**HaskoningDHV UK Ltd.
Transport & Planning**

To: North Hertfordshire District Council
From: Phil Marshall
Date: 30 October 2020
Copy:
Our reference: PC1534-RHD-NT-0001-NT-0002
Classification: Project related
Checked by: Phil Marshall

Subject: Planning Application Ref: 20/00744/OP - Review of Gladman Response

Insert 2 – Bridleway 13

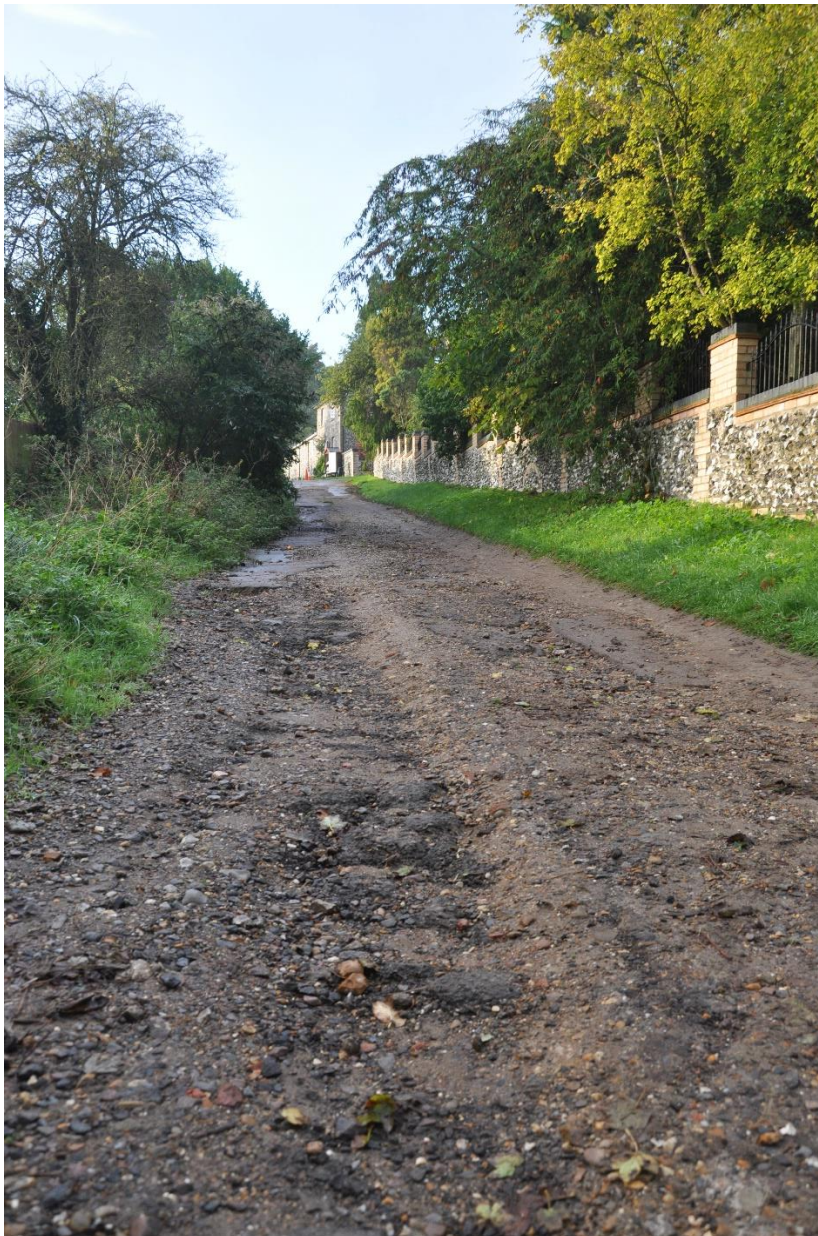
It is also noted that the applicant has removed the intent to use Bridleway BW R013 as a secondary vehicular point. However walking and cycling access is still proposed. The bridleway is poorly surfaced, unlit and would not meet current design standards, especially in terms of permissible gradients for access by the mobility impaired. The condition of the Bridleway continues to deteriorate; see Insert 2.

No drawings have been provided to demonstrate that the applicant could suitably improve the Bridleway. Furthermore it is unclear whether the applicant has the right to make any improvements, as the Conservators have objected to the development:
